**TO:** City Plan Board **Item Number:** 2  
**FROM:** Planning & Development Services **DATE:** May 26, 2016  
**Department Staff**  
**SUBJECT:** Petition PB-16-39 SUP. eda engineers-surveyors-planners, inc., agent for Prairie View Trust, owner. Special use permit with major development plan review to allow the construction of a hotel. Zoned MU-1 (8-30 units/acre mixed use low intensity). Located at 3989 SW 37<sup>th</sup> Boulevard.

# FAIRFIELD INN & SUITES HOTEL

F A I R F I E L D  
S I T E P H O T O M E T R I C P L A N  
S W 3 7 T H B L V D  
G A I N E S V I L L E , F L

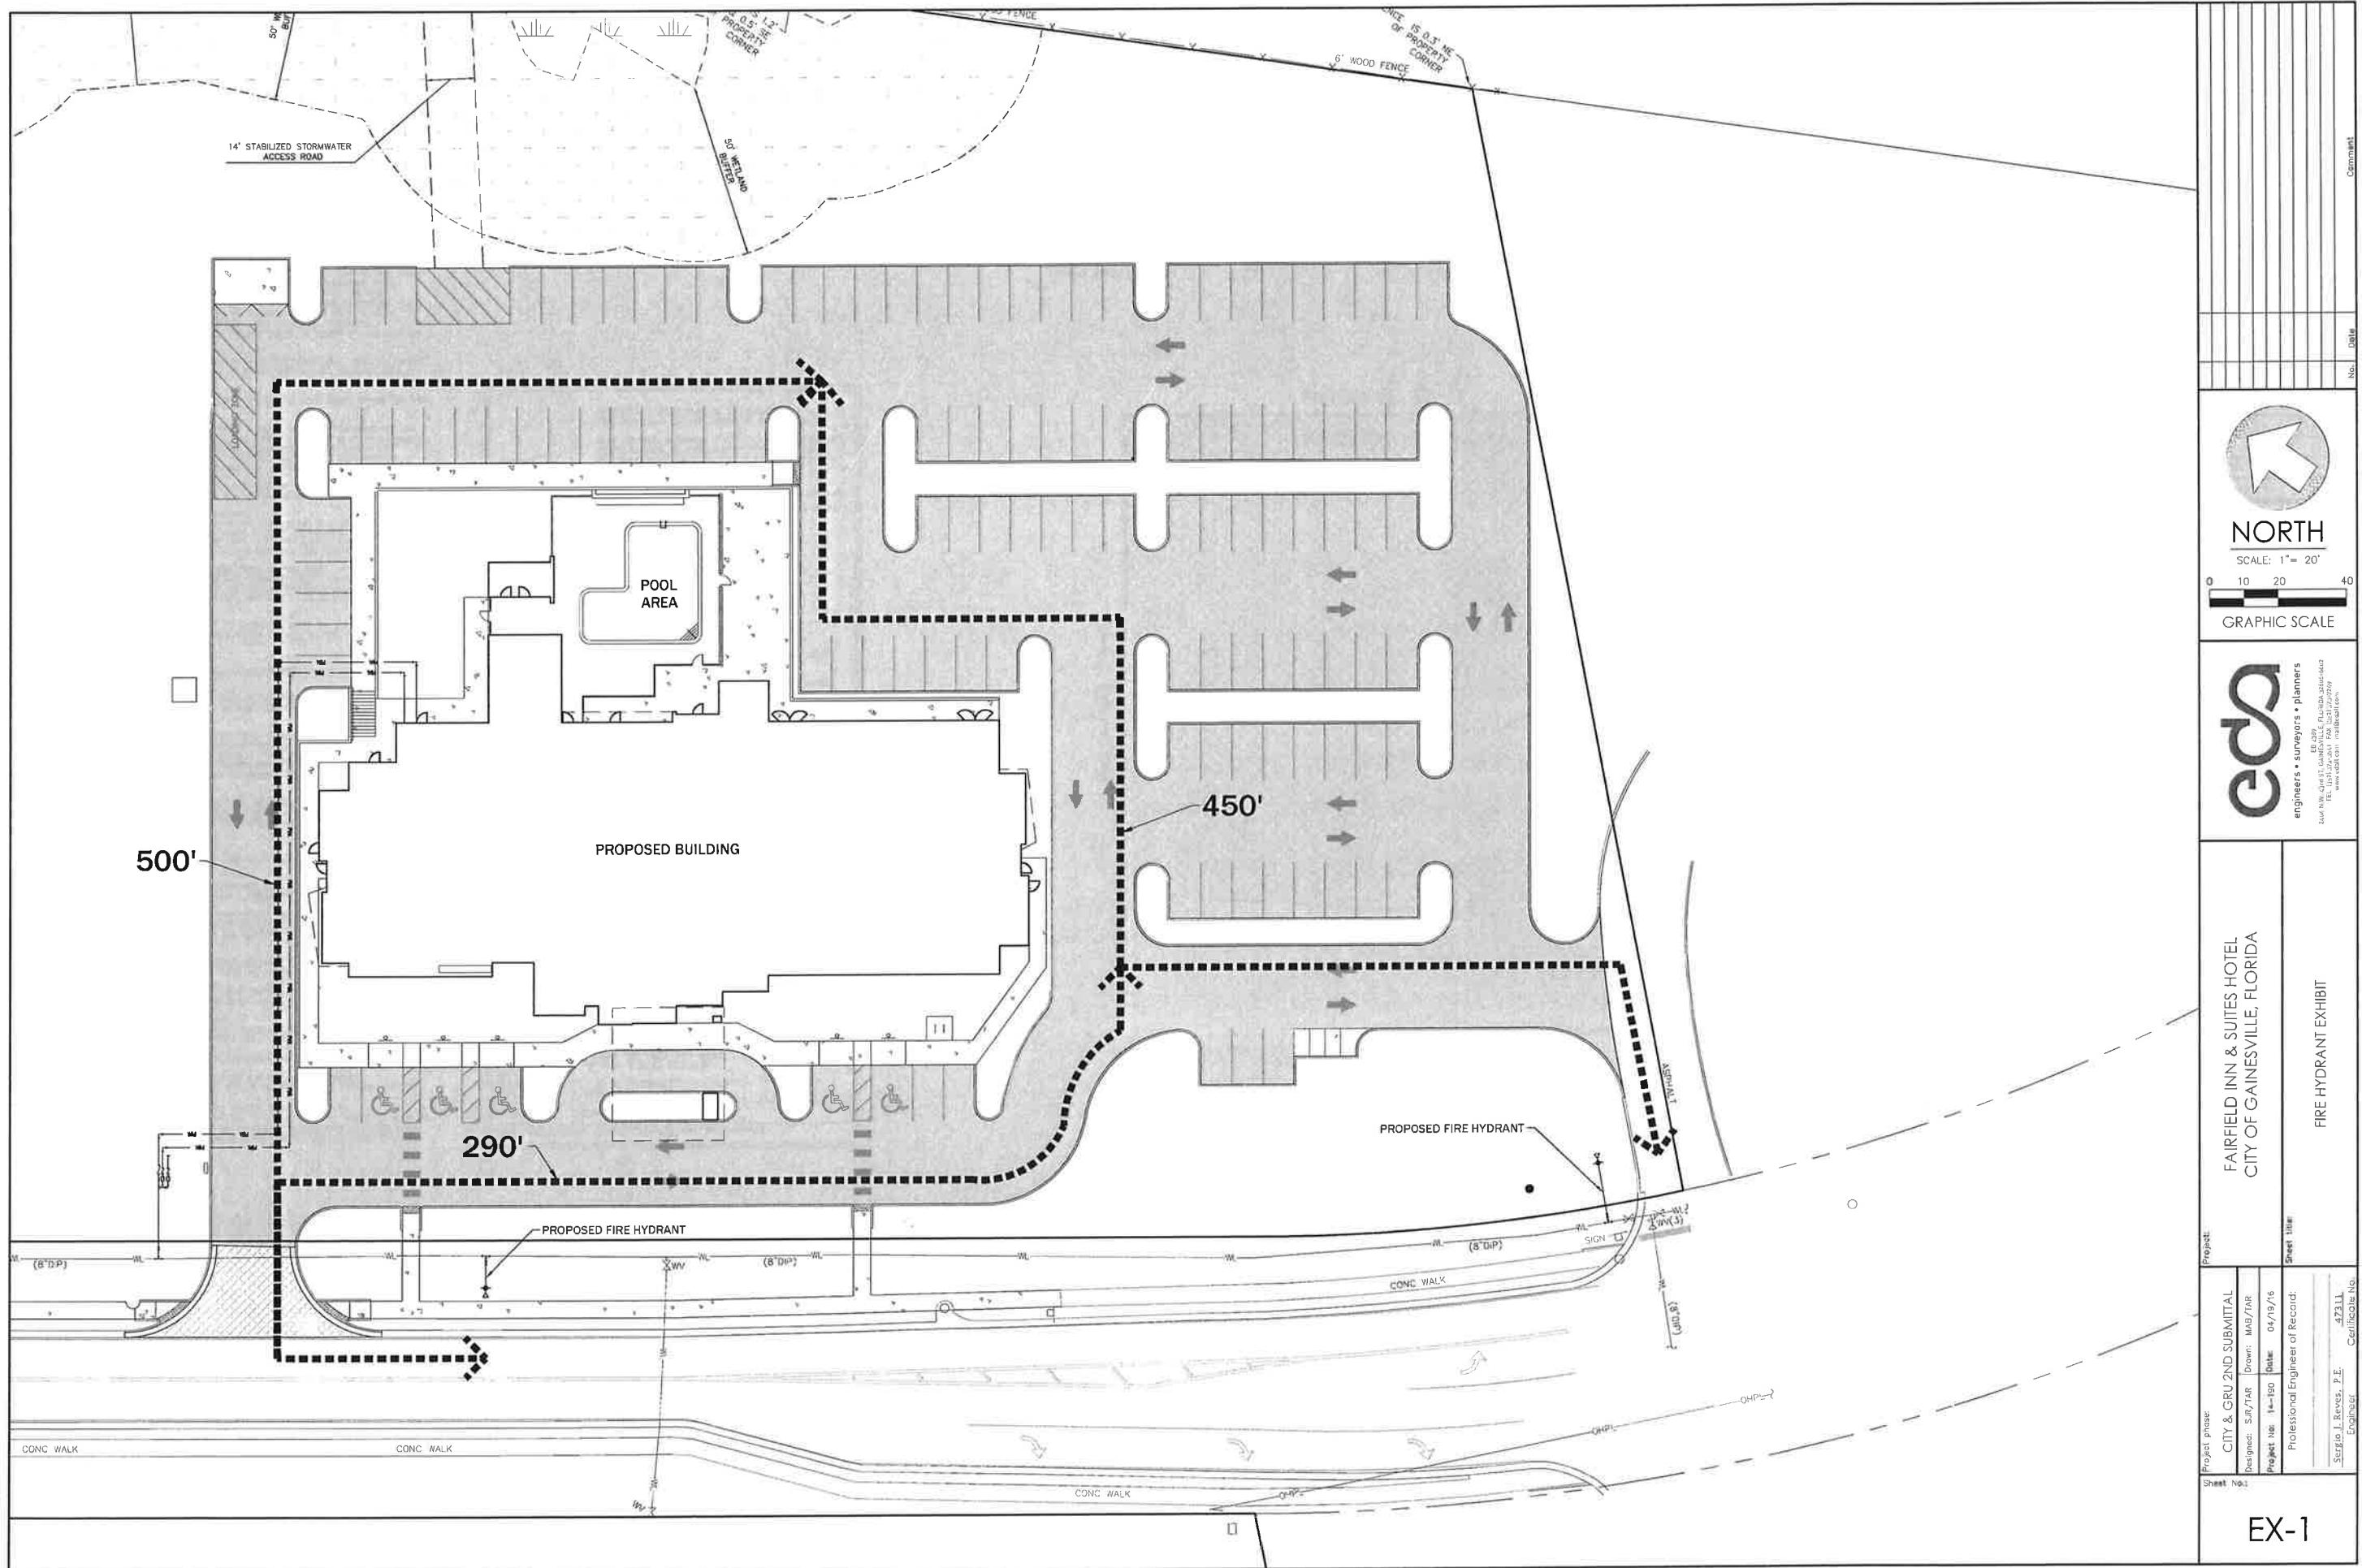
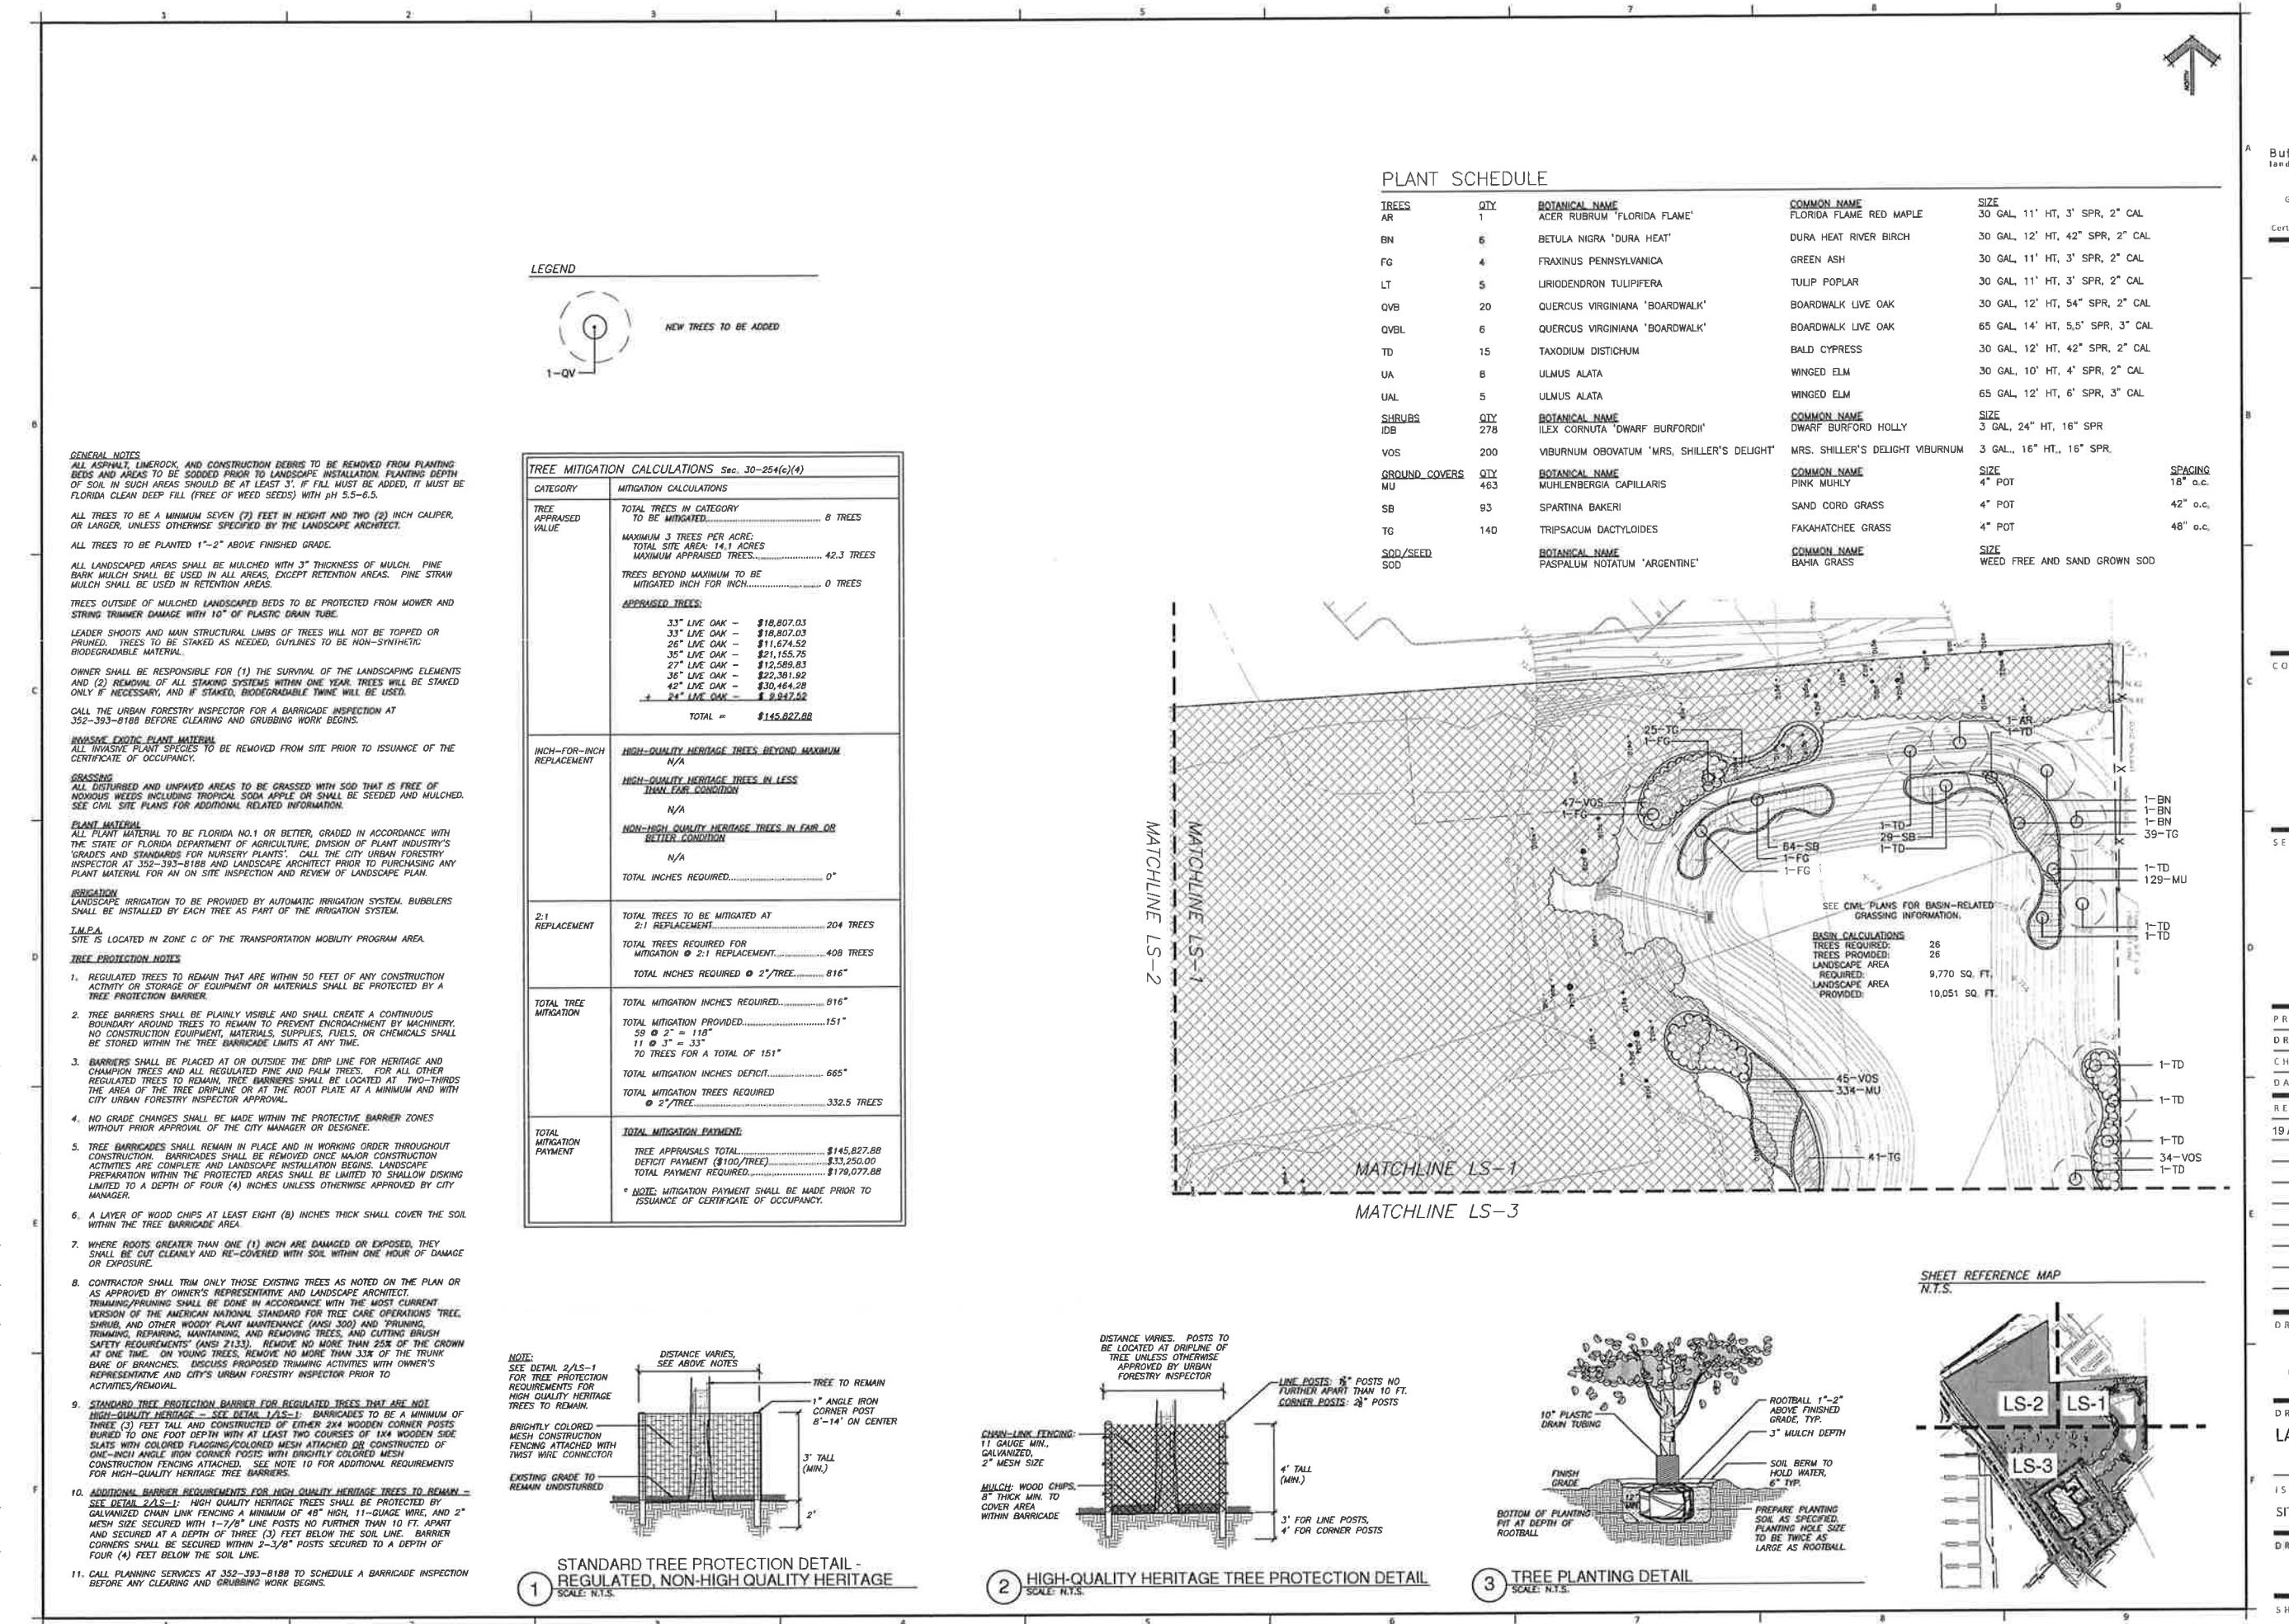
10. The photometric narrative must be corrected. The photometric plan shows at least 3 proposed light poles with a height of 30 feet, w/n 75 feet of property with a residential zoning designation. The height of the poles must be changed to comply with the maximum 15 feet allowed, or the applicant must obtain a board-approved waiver.

1 DUMPSTER PLAN  
A6.28 SCALE: 1/4" = 1'-0"

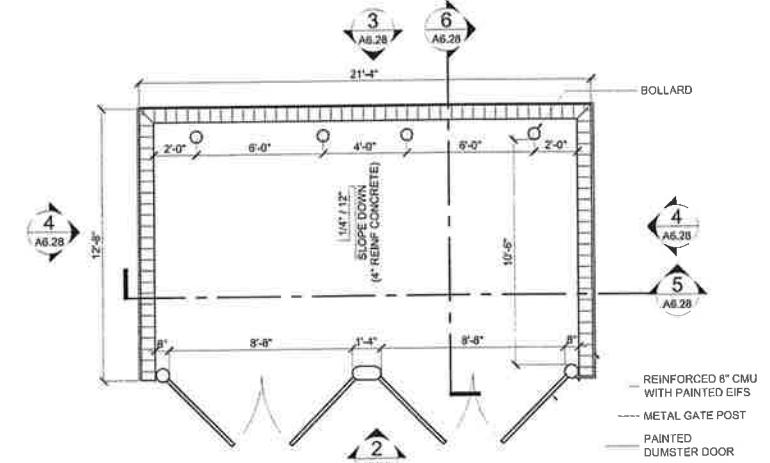
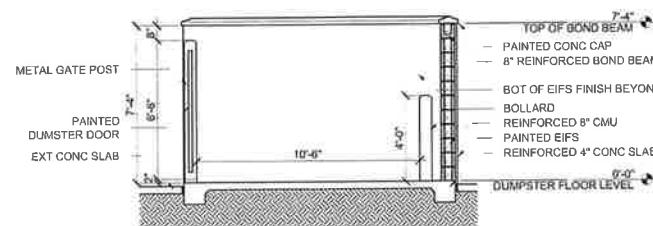
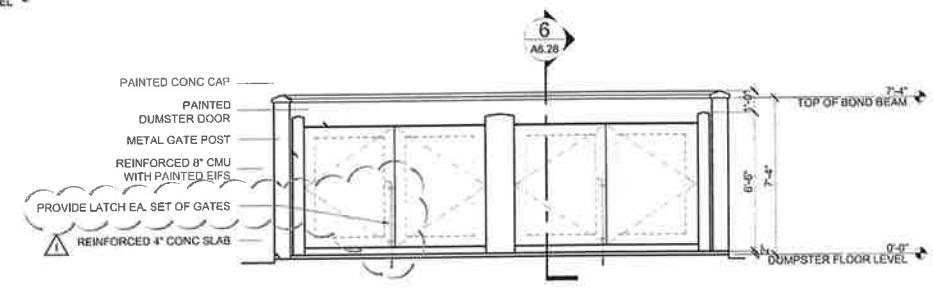
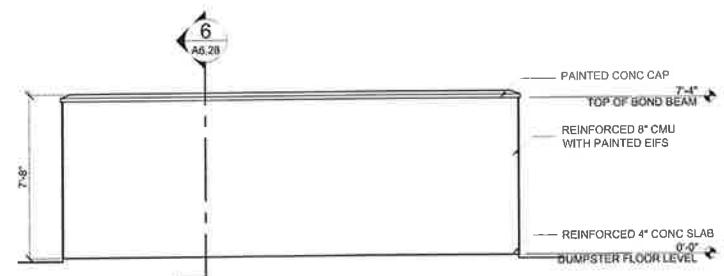
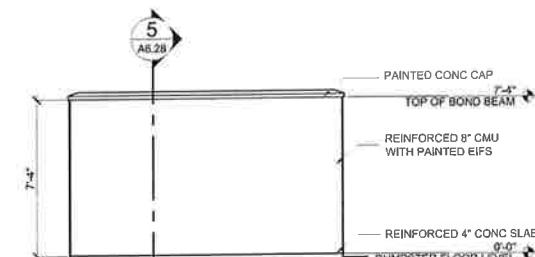
5. Please provide a note with the dumpster detail indicating whether the exterior of the enclosure will be finished to match the exterior of the principal building. Also, please note where a latch for the gates will be provided.

NOTES:  
- FINISH SHALL MATCH THE EXTERIOR OF THE PRINCIPAL BUILDING
